Office Action Summary

10/655,964

DETAILED ACTION

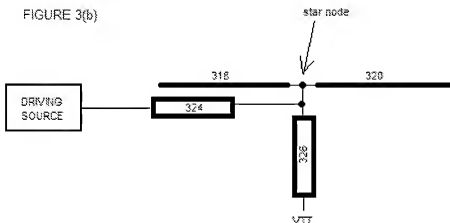
With respect to applicant's arguments on pages 10 (last paragraph) and 11 (first paragraph) that Johnson does not anticipate "a parallel termination impedance having one end coupled to said transmission line between said series dampening impedance and said branch point, wherein said parallel termination impedance is on the same side of any memory module as said driver", the Examiner respectfully disagrees. The circuit as shown below (Figure 3b) is **equivalent** to the circuit shown in Figure 3 of Johnson. The Examiner would also like to note that it is irrelevant how these schematics are drawn as long as the connections/nodes are the same, since it is merely a matter of drawing choice.

Therefore, the parallel termination impedance (326) is **between** the series dampening impedance (324) and the branch point (star node) and the parallel termination impedance (326 – where 326 is parallel in reference to V_{TT} and star node) is on the same side (below memory modules 302-308) as the driver (312).

With respect to applicant's arguments on page 13 (first paragraph) that "the combination of Johnson and Buuck fails to suggest the features of Applicant's Claim 1 as a whole", the Examiner respectfully disagrees. As shown above, Johnson teaches the termination impedance (326) is between the dampening impedance (324) and the branch point (star node). The Examiner also agrees with the statement in the second paragraph of Page 13, however would like to clarify that Johnson teaches these limitations and Buuck teaches the limitations of claim 6 (as well as claim 20).

a parallel termination impedance (326 – where 326 is parallel in reference to V_{TT} and star node) having one end coupled to said transmission line (314) between (see Figure 3b as shown above) said dampening impedance (324) and said branch point (star node), wherein said parallel termination impedance (326) is on a same side of any memory module as said driver (where Figure 3b shows 326 and driving source below the memory modules);
